**Before the Hearings Panel
At Wellington City Council**

In the matter of the Proposed Wellington City District Plan

**Stream 3 Reporting Officer Further Right of Reply of Anna Mariebel
Sutherland Stevens on behalf of Wellington City Council – Viewshafts Follow
Up**

Date: 14 September 2023

Figure 6 shows VS 15 base in 3D. The base intersects the top of the 38m Dorchester Apartments, 144 Oriental Parade, starting from the cable car viewing platform as outlined in SCHED5. This results in the base of the viewshaft cutting through Mount Victoria and Oriental Bay.

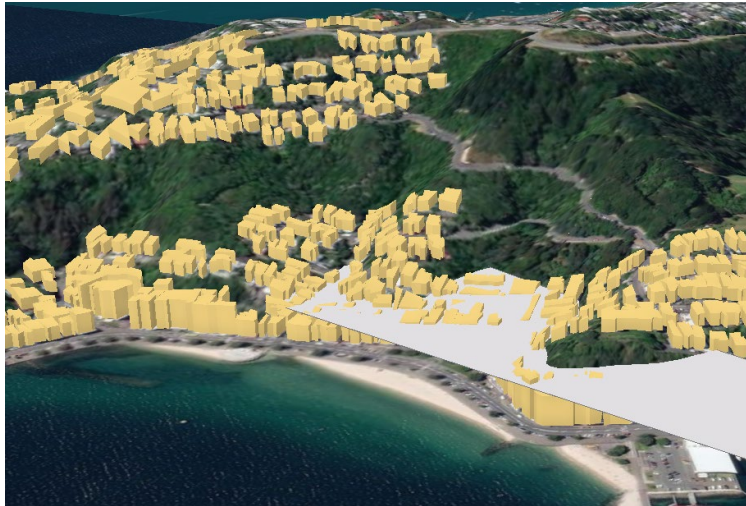
- 112 The viewshafts were modelled as 2D planes representing the base of the viewshafts, with the side margins delineated by the descriptions provided in SCHED5 and cross referenced with satellite imagery. These 2D planes were projected across a 3D model of the city showing the topography of the landform and 3D footprint of existing buildings under different height control scenarios. The final model shows where existing buildings, or any sites developed to the maximum height under any given scenario would intrude into the current viewshafts. An example of the 2D model versus the 3D model is provided in Figures 6 and 7 below.

Figure 8: Scenario 1 height limits for the medium density residential zone, showing a minor intrusion into Viewshaft 13.

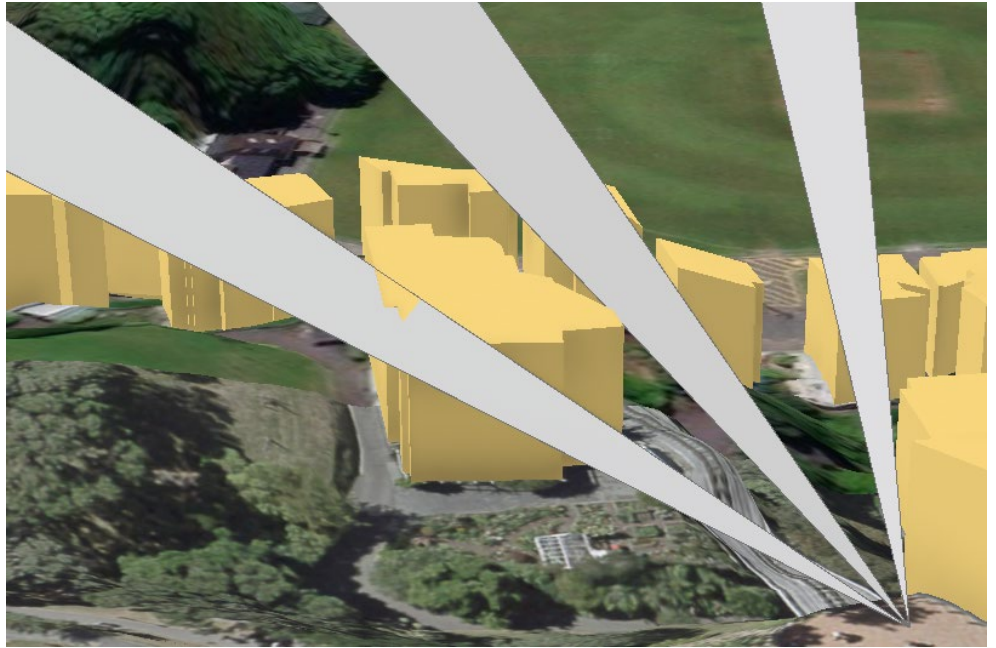
117 Under height scenario 1 with the existing building footprint model only (shown in yellow in Figure 8 below), an 11m height limit shows a slight intrusion into the right half of the base of VS13 (See Figure 9 below). No other Viewshafts have intrusions under this model assumption for this scenario’s heights. However, there is a very slight intrusion into VS14 and VS15, with no further intrusion into VS13, utilising the entire site assumption model (See Figure 9 below). Of note is that the entirety of this slight intrusion into VS14 overlaps with the cable car path heritage area, which is unlikely to ever be developed beyond its current state.

Figure 10: Showing the further intrusion into VS13 from a 14m height limit in the MRZ.

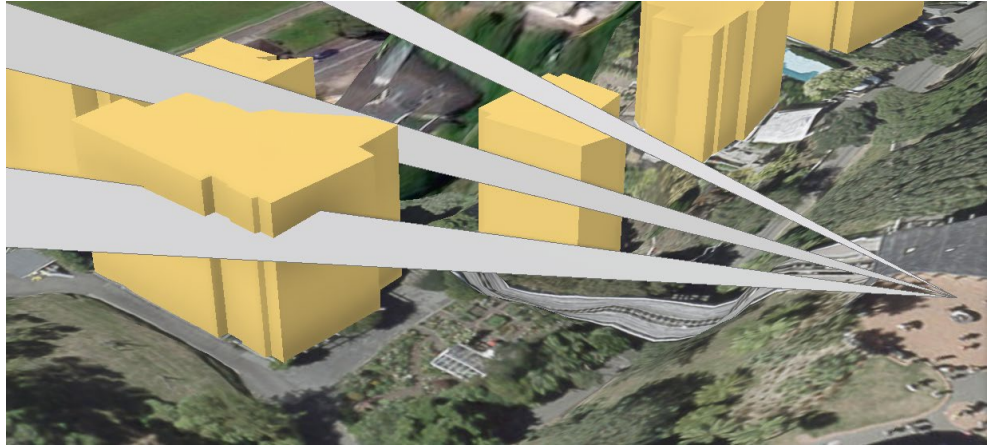
118 Under height scenario 2 for the existing building footprints model, the intrusions are similar to height scenario 1. The intrusion into the right side of VS13 is more significant due to the increase in height to 14m in

the MRZ (See Figure 10). There is no change to VS14 and VS15 under this scenario for existing building footprints. For height scenario 2 across the entire site footprint model, there is a greater extent of intrusions into VS13–15, as well as an increase to the height of these intrusions to be more significant than that seen under height scenario 1 (See Figure 11).

Figure 12: showing the intrusions from properties below the cable car view platform from a height of 22m in this zone.

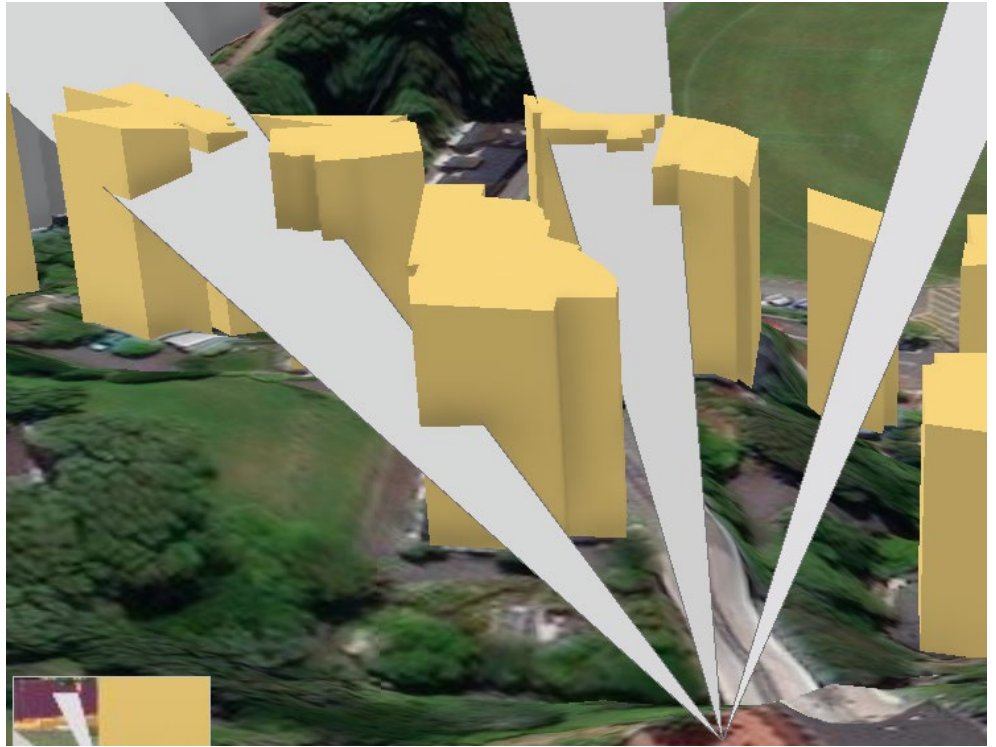
120 Height scenario 4 for the existing building footprint model shows that the intrusion into the right side of VS13 is very significant at 22m, with the intrusion from sites further down the hill in the MRZ zoned area covering almost the entire base of the viewshaft with varying heights of intrusion due to the slope of the land. There also begins to be an intrusion into VS14 at this height scenario, whilst VS15 still has no intrusions (See Figure 12). As with height scenario 3, there is no intrusion into the base of the 3 viewshafts from any areas zoned HRZ as notified.

121 For height scenario 4 with the entire site footprint model, the views are significantly blocked (See Figure 13).

Figure 14: showing VS13 (Left) and VS14 (middle) being completely blocked by 43m height limit on the existing building footprint model for height scenario 5.

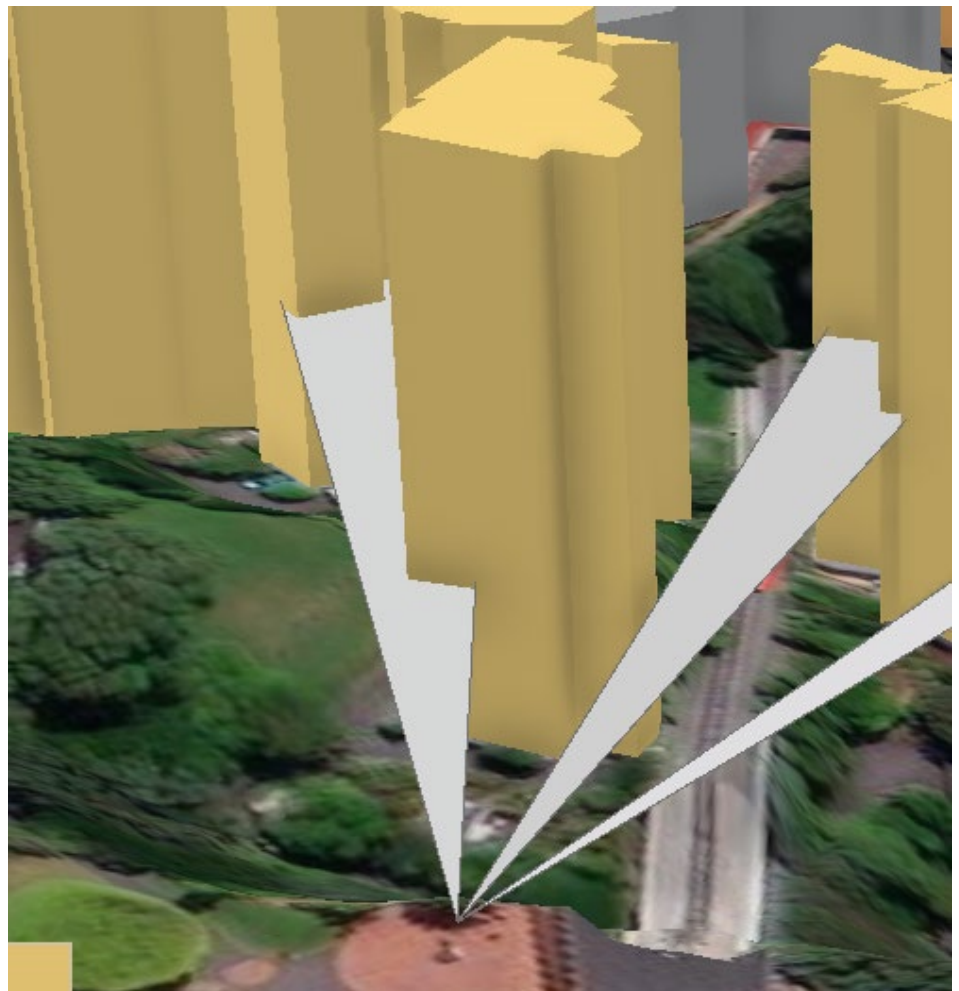
- 122 Height scenario 5 under the existing building footprint model shows both VS13 and VS14 being completely blocked (See Figure 14). VS15 has approximately a third of the right margin of the view blocked under height scenario 5 (See Figure 15). Height scenario 5 under the entire site footprint model shows that all 3 viewshafts are full intruded upon (See Figure 16 below).
- 123 The HRZ bordering the CCZ begins to intrude into VS13 and VS14 with a 43m height limit under both the existing building footprint view and entire site footprint view (See Figure 17).

Figure 18: Showing Viewshaft Viewer modelling of MRZ-PREC03 maximum height limits under PDP-VS15 with monastery focal element in view.

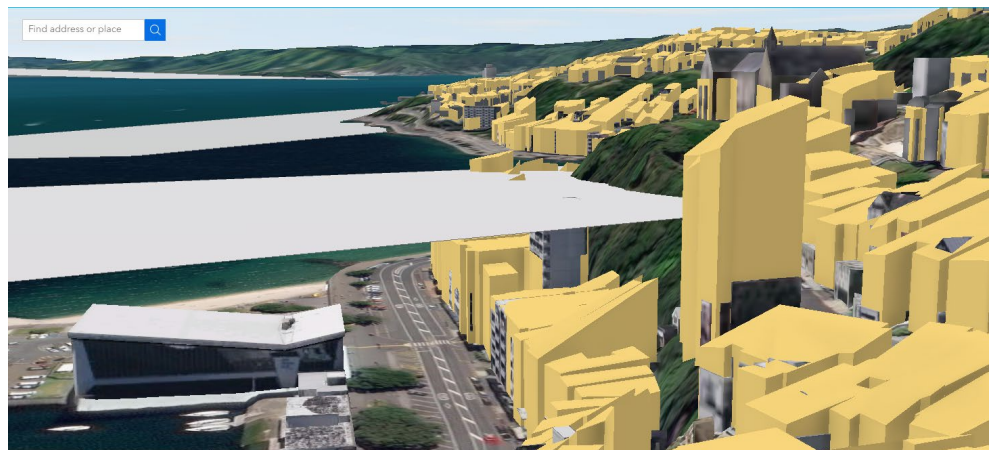
129 I note that the same Viewshaft provisions treatment needs to be applied to the Oriental Bay Height Precinct (MRZ-PREC01) which sits underneath PDP-VS15. If these MRZ-PREC01-S3 maximum height limits, as included in the notified PDP, were to no longer apply (as sought by Kainga Ora's submission) and this area became HRZ because of the walking catchment of the CCZ then there is a risk that 22m would intrude upon PDP-VS15 to St Gerard's Monastery, noting this sits underneath the Monastery. Figures 18 and 19 below shows the current effect of the MRZ-PREC03 height limits with regard to PDP-VS15.
